2nd Row Seat Tilt Feature Change

21MY RR Discovery

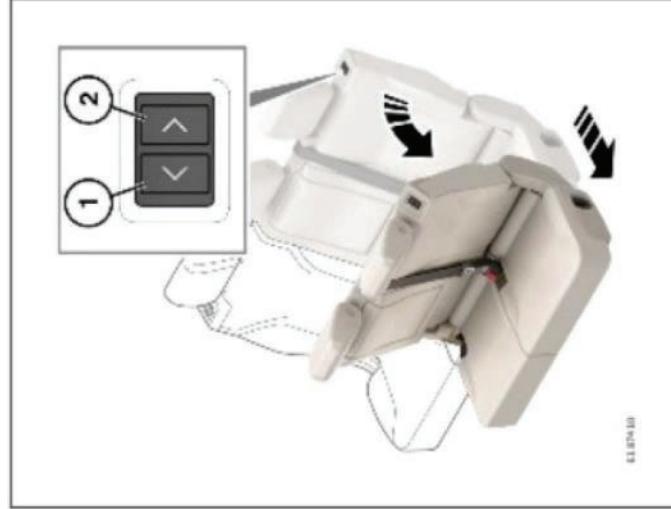
- The seat module software strategy has changed for 21MY for this feature. The rear window isolator button will now inhibit the 2nd row seat tilt switch located on the top of the seat as well as the rear windows.
- The load space switch and the front touch screen will still tilt/ fold the 2nd row seats regardless of the rear window isolation switch position.

- Should a customer express a concern, please ensure the rear window isolation switch is not activated to inhibit seat movement from the seat switch.
- SSM 75319 has been published to inform you of this change in operation.
